Work Order ID 141148

Item ID: D206-642-341BL Accept ***N900040100*** Setup Start ***NS1***
 Revision ID: Stop ***NS2***
 Item Name: Replacement Skidtube (Fits LH or RH)
 Start Date: 1/28/2016 Start Qty: 1.00 ***1*** Cust Item ID:
 Required Date: 3/3/2016 Req'd Qty: 1.00 ***1*** Customer:
 Reference:

DRAWING NO. D2650	TITLE 206/407 SKIDTUBE ASSEMBLIES	REV. F	DART AEROSPACE LTD ENGINEERING ORDER		D.E.O. NO. D2650-F-1	SHEET NO. SHEET 1 OF 1	SCALE NTS
DRAWN <i>JP</i>	CHECKED <i>A.P.</i>	MFG. APPR. <i>DA</i>	APPROVED <i>[Signature]</i>		DE APPR. <i>[Signature]</i>		
DATE 12.10.12	DATE 12.10.22	DATE 12.10.22	DATE 12.10.22		DATE 12.10.22

CHANGE C'BORED WELDED CROSSBOLT SPACERS TO SWAGED SPACERS

AMENDMENT TO DETAIL B
NOT TO SCALE

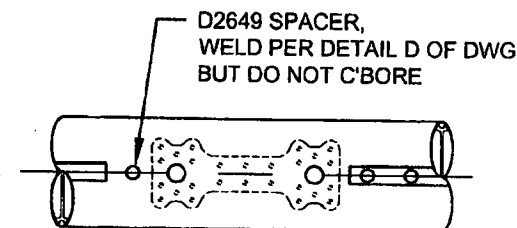
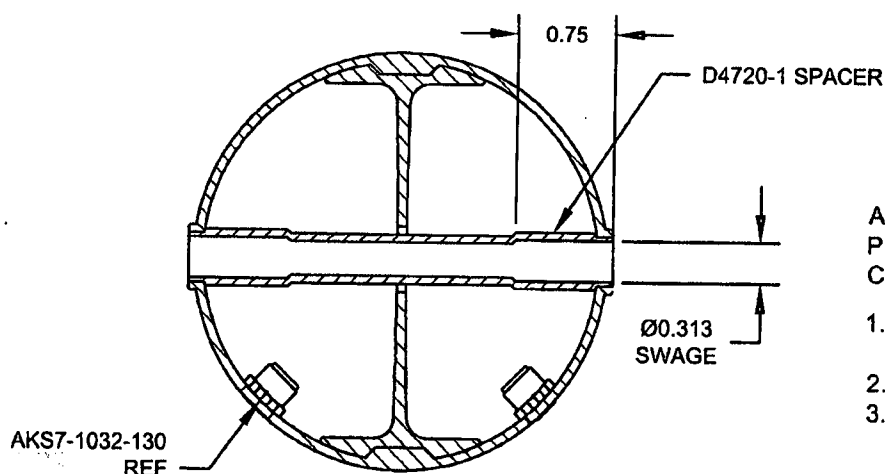
ADD DETAIL G BELOW, WHICH IS THE SAME SECTION VIEW AS DETAIL D OF DWG.
C'BORED HOLES ARE **NOW SWAGED** PER DETAIL G BELOW. FOR THE Ø0.375 HOLE THAT IS NOT C'BORED, WELD PER DETAIL D OF DWG (SEE AMENDED DETAIL B FOR REFERENCE).

AFTER DRILLING AND BENDING ASSEMBLY
PERFORM THE FOLLOWING FOR Ø0.375 HOLES THAT ARE
CURRENTLY C'BORED:

1. INSERT D4720-1 SPACER, 16 PL (-1) OR 17 PL (-3)
OR 19 PL (-5) OR 23 PL (-7)
2. SWAGE TO Ø0.313 X 0.75 DP PER QSI 002
3. TRIM / GRIND FLUSH PER QSI 002
